Docket Item # 11
BAR CASE # 2008-0096

BAR Meeting
July 9, 2008

ISSUE: Alterations

LOCATION: 1200A King Street

Figure 3: Proposed site plan showing base and lighting poles

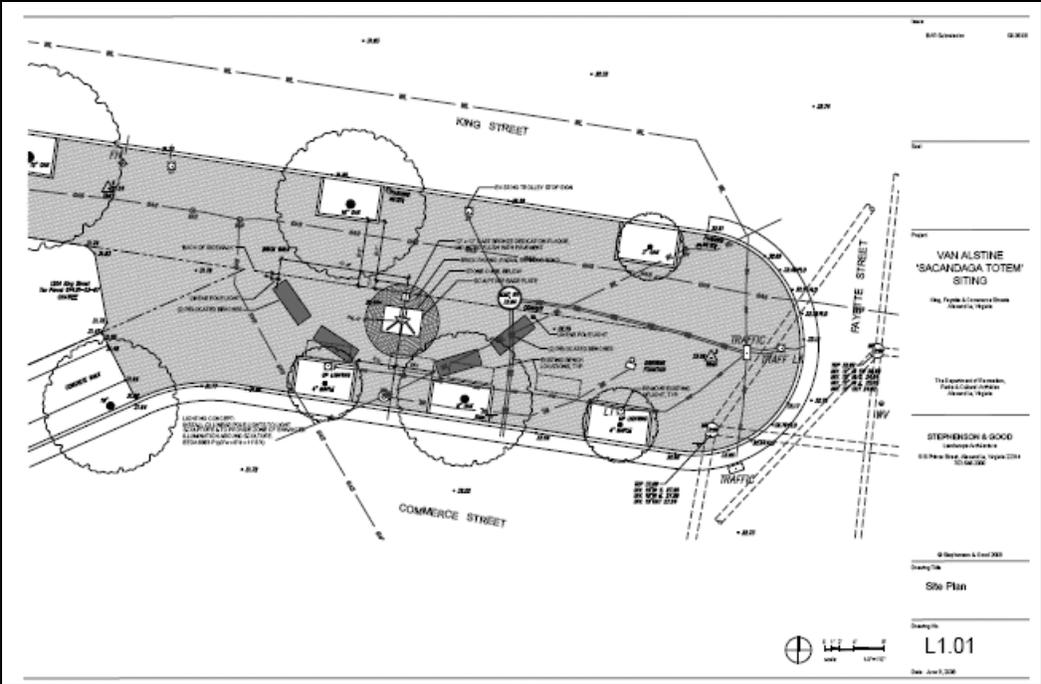
In Staff's opinion, the proposed base and lighting are appropriate in this context and for this use. The applicant worked with Staff to develop a base design that was minimal, yet compatible to the existing design of the plaza. The radial design provides a paving focal point for the sculpture within the plaza, without being too distracting or competing with the existing paving. The base itself is minimal in height and design, and allows the sculpture itself to be the dominate element in the plaza.

The proposed lighting poles are appropriately "background" elements and do not detract from the more traditional street lamps currently in the plaza. The lighting levels are minimal to provide some nighttime illumination to the totem sculpture.
